Product Change Notification

Change Notification #: 105669 - 01
Change Title: SC5300, PCN 105669-01, FYI, Class 2:
Adding notch to metal bracket between fans
to better accommodate cable routing between
hard drive bays
Date of Publication: December 02, 2005

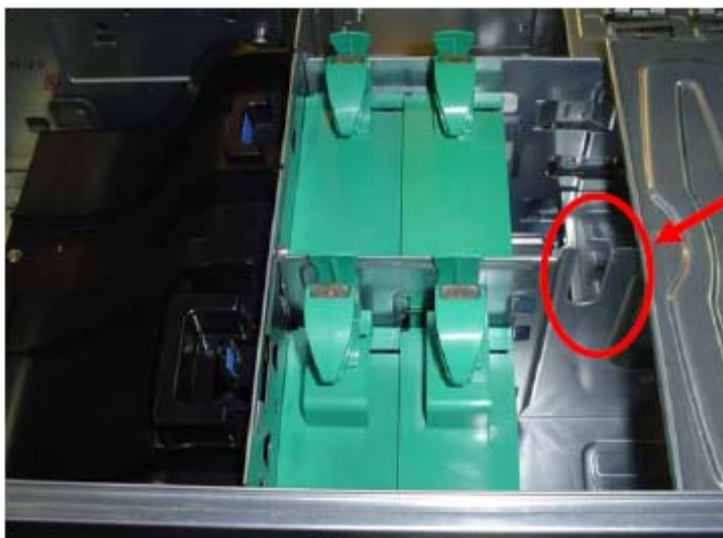
Improvement design change by adding notch to metal bracket between fans to better accommodate cable routing between hard drive bays (refer to picture below).
